**AGENDA
FARRAGUT MUNICIPAL PLANNING COMMISSION**

**March 15, 2018
7:00 p.m. Farragut Town Hall**

**SUBJECT: STAFF COMMENTS ON THE SITE PLAN FOR THE AT HOME,
11501 PARKSIDE DRIVE**

**SUBJECT: STAFF COMMENTS ON THE CONCEPT PLAN FOR THE
BROOKMERE SUBDIVISION, PARCEL 044, TAX MAP 152, 430 VIRTUE
ROAD**

SHEET TITLE
PHYSICAL FEATURES
INVENTORY SHEET

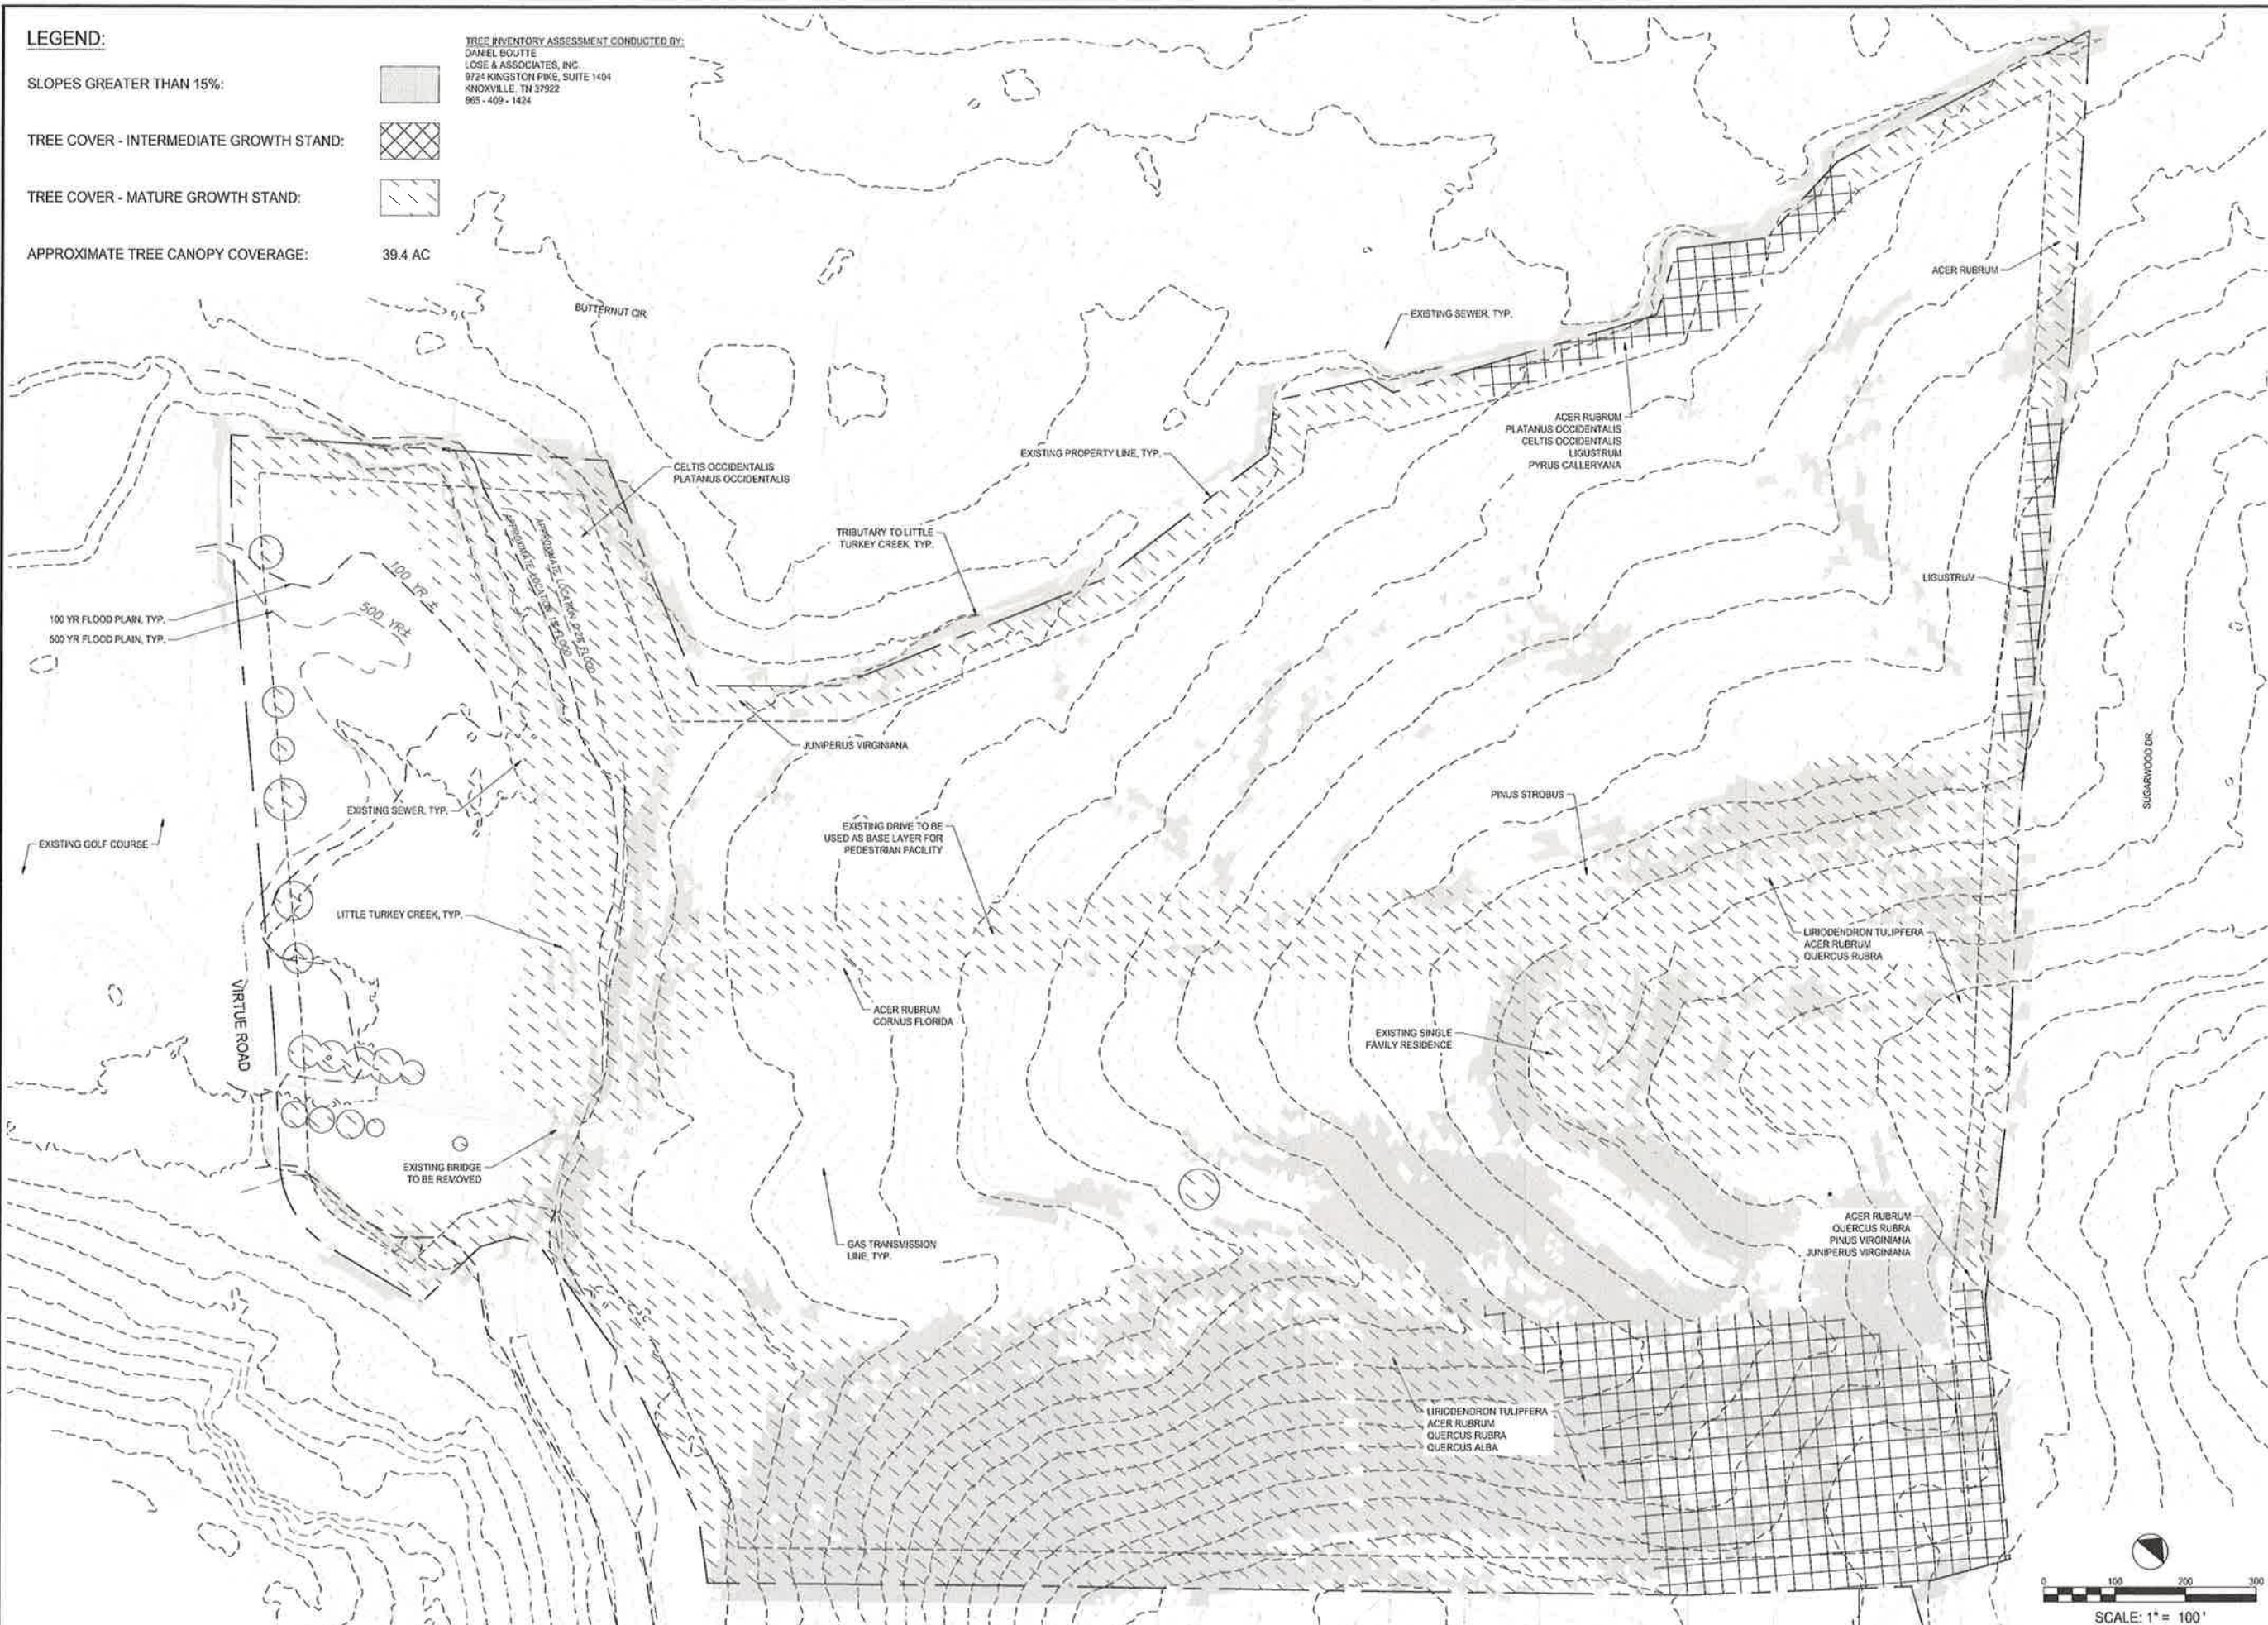
- 3) Please clarify that the existing driveway and bridge for the driveway will be removed as part of this development;
- 4) The rezoning was conditioned on the execution of a cost share agreement for improvements to Virtue Road. This must be completed as a condition of approval of the concept plan;

- 9) On the physical features sheet, please include (as applicable) the names and contact information for all professionals involved in the inventory assessment;

Response: This information has been added in the Physical Inventory Sheet (Sheet #3).

Response: This information has been added to the Physical Inventory Sheet (Sheet #3).

SHEET TITLE
OVERALL LAYOUT AND
TRANSPORTATION
SHEET

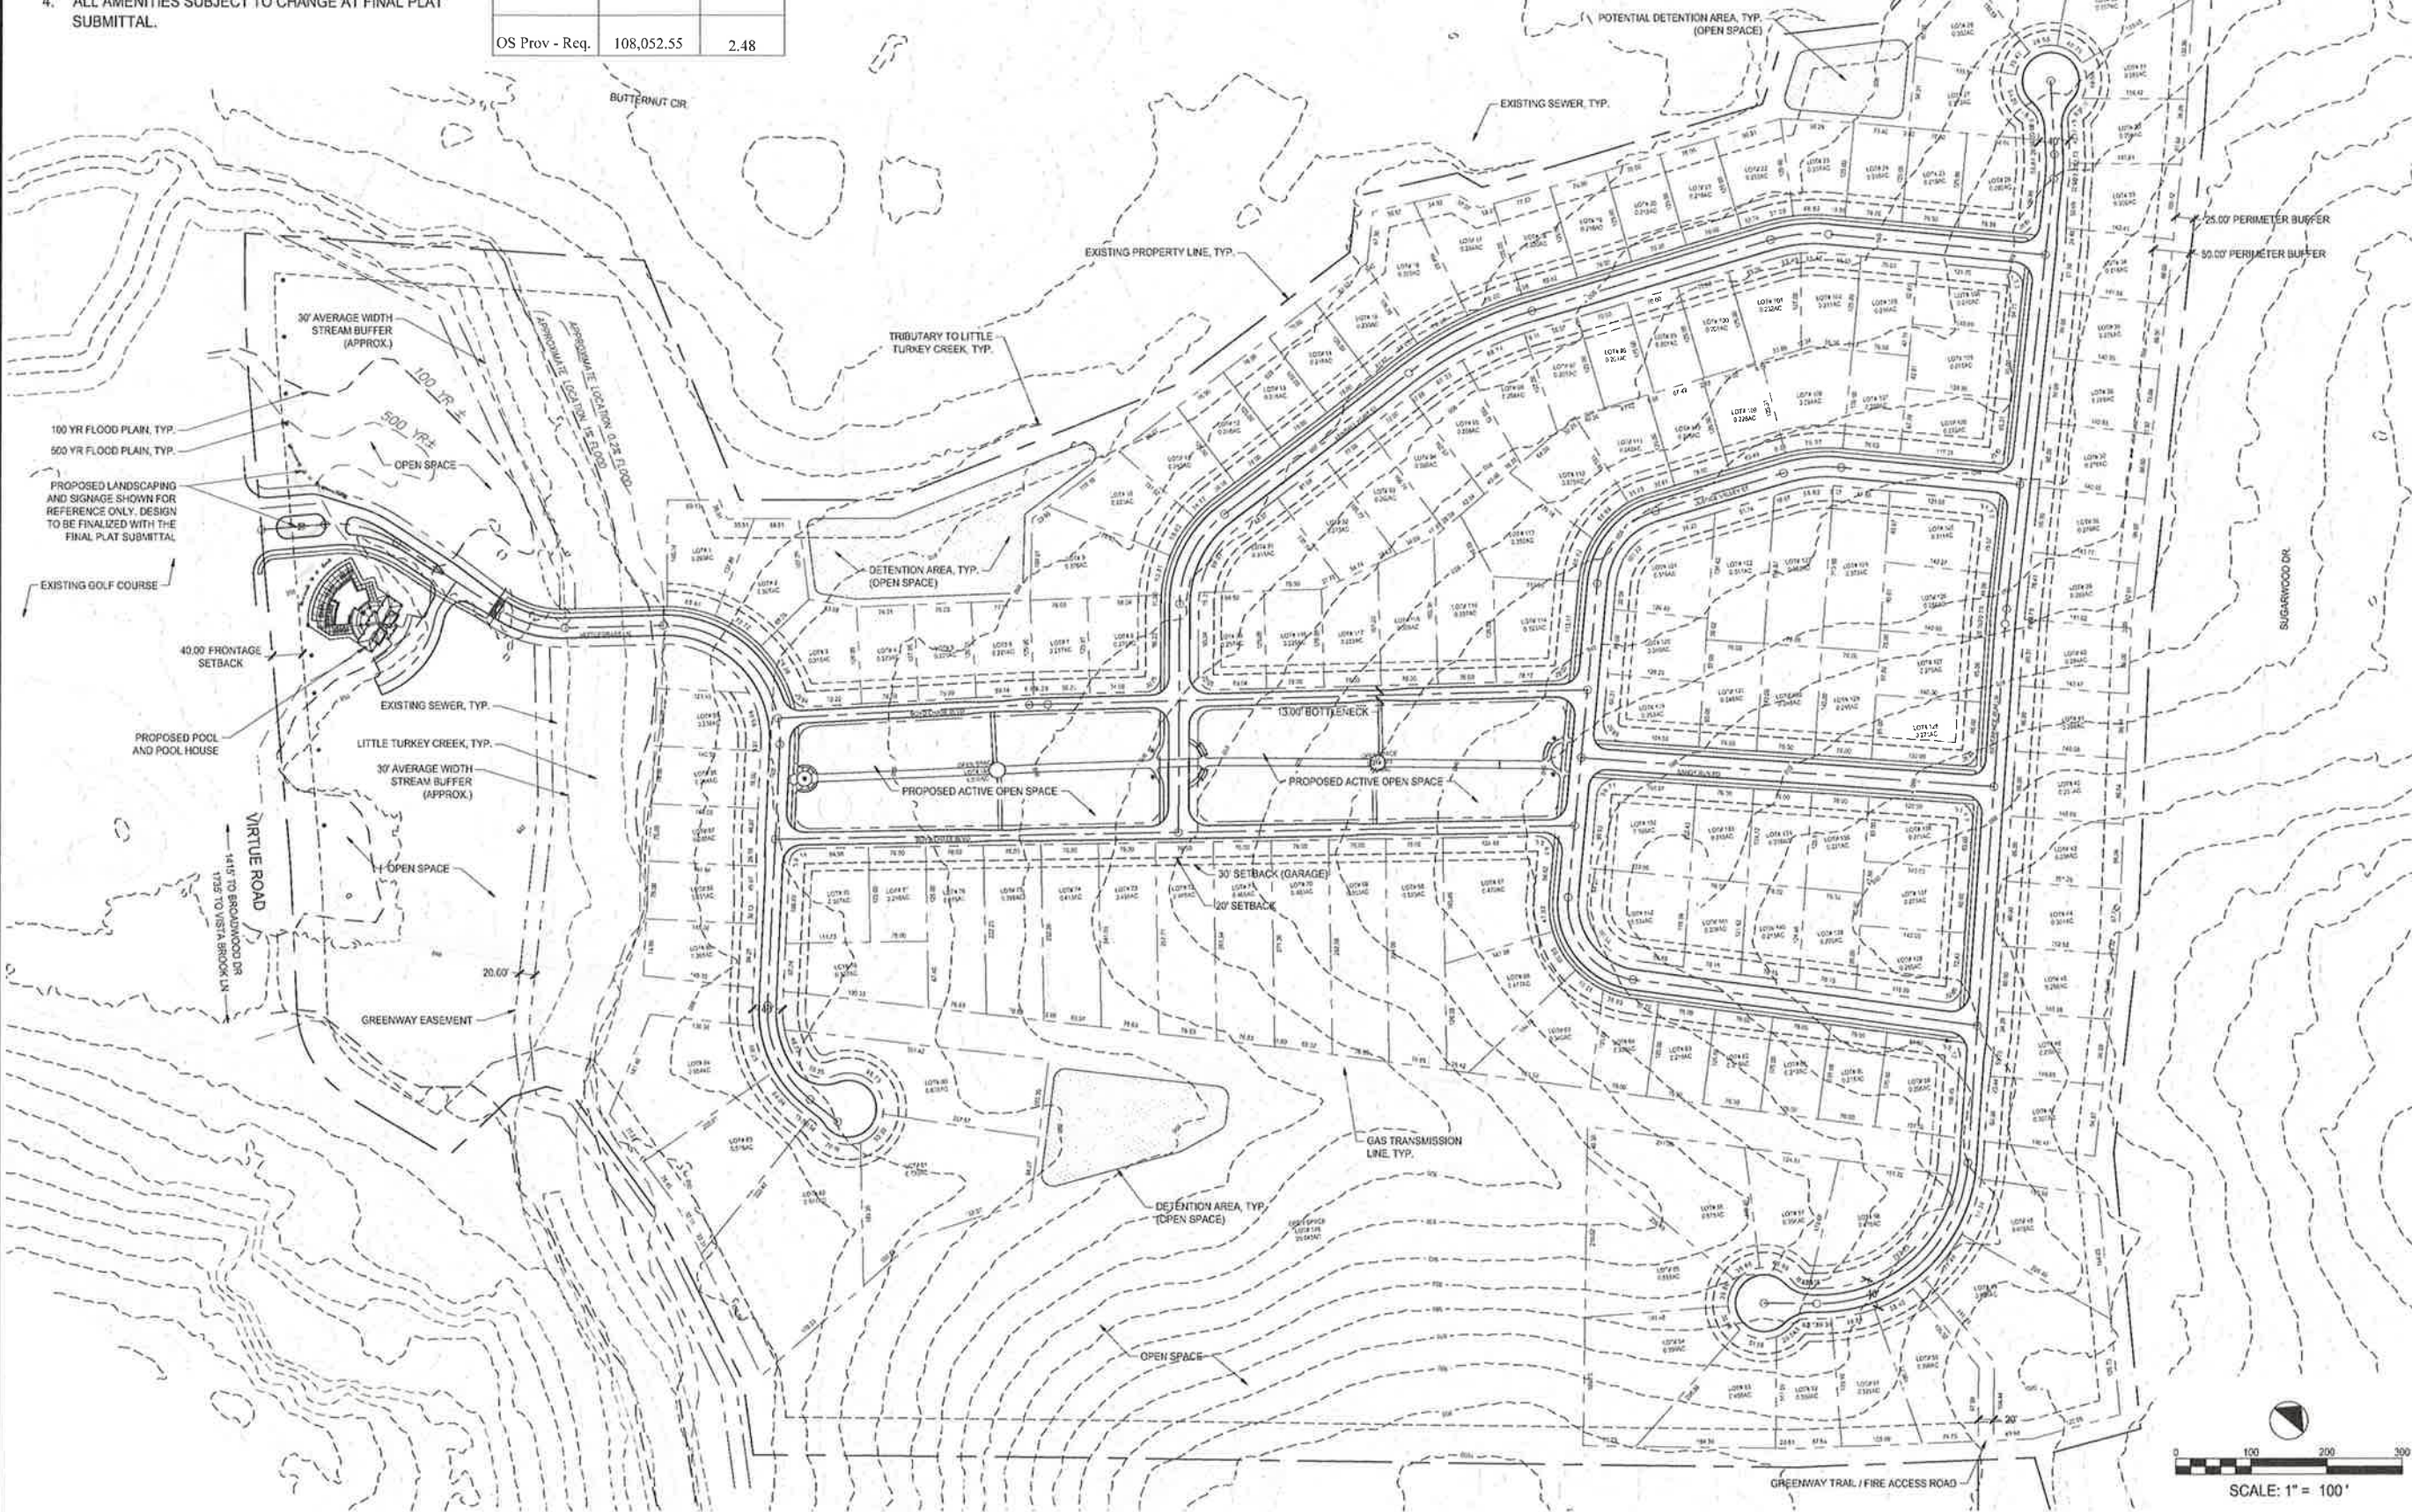
- 16) Please show and label the 50 foot peripheral setback;
- 17) Please show the open space as its own separate and numbered lot. A note is also needed that the open space is to be owned and maintained by the Brookmere Homeowner's Association (assuming Brookmere is approved by Knox County Addressing as an acceptable name);

Response: 50 foot peripheral setback is now shown and labeled on the Overall Layout and Transportation sheet (Sheet 4).

Response: The open space now has its own separate and numbered lot. The additional note has been placed on the overall layout and transportation sheet (Sheet #4).

STREETSCAPE SHEET

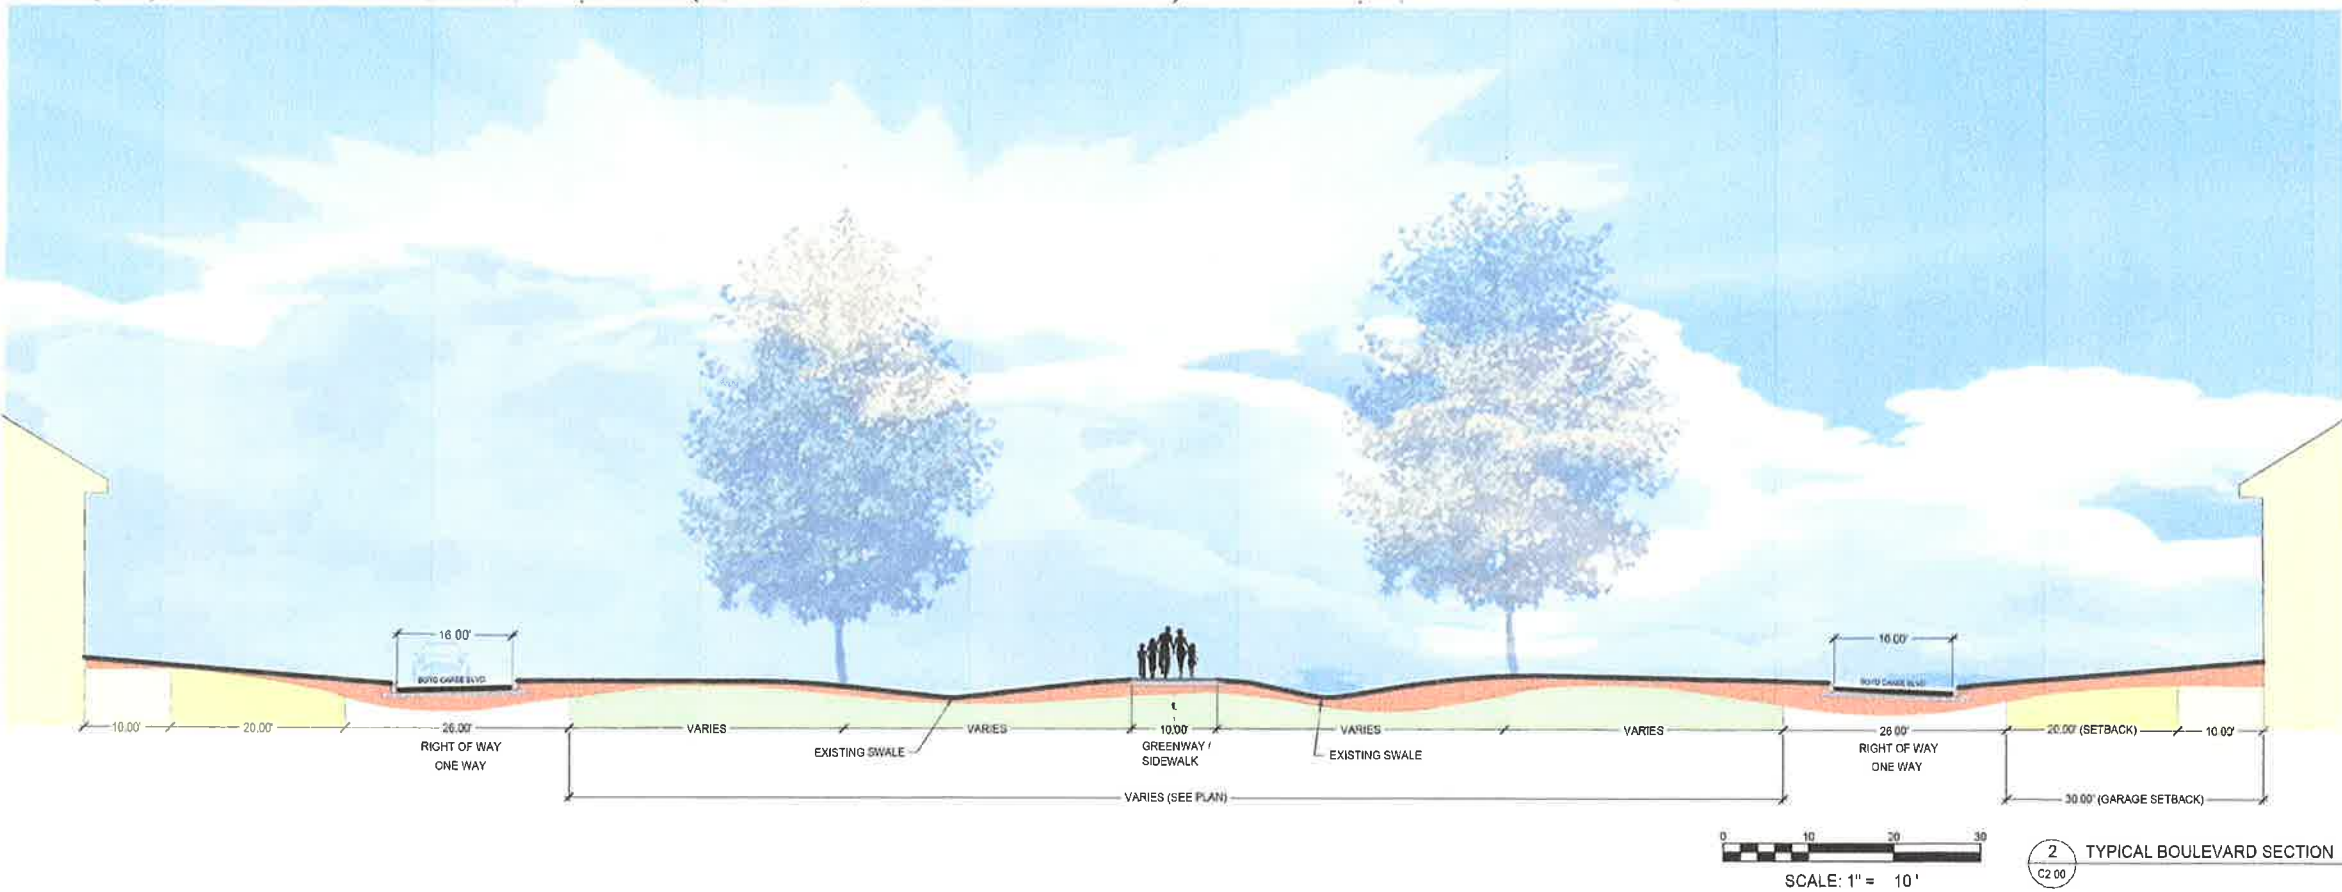
- 20) The streetscape plan should be expanded to include entrance elements and if any street trees or other streetscape enhancements are proposed along other streets or street sections;

Response: Conceptual landscaping and entry signage has been added to Sheet 4. The final design will be determined at the Preliminary Plat submittal.
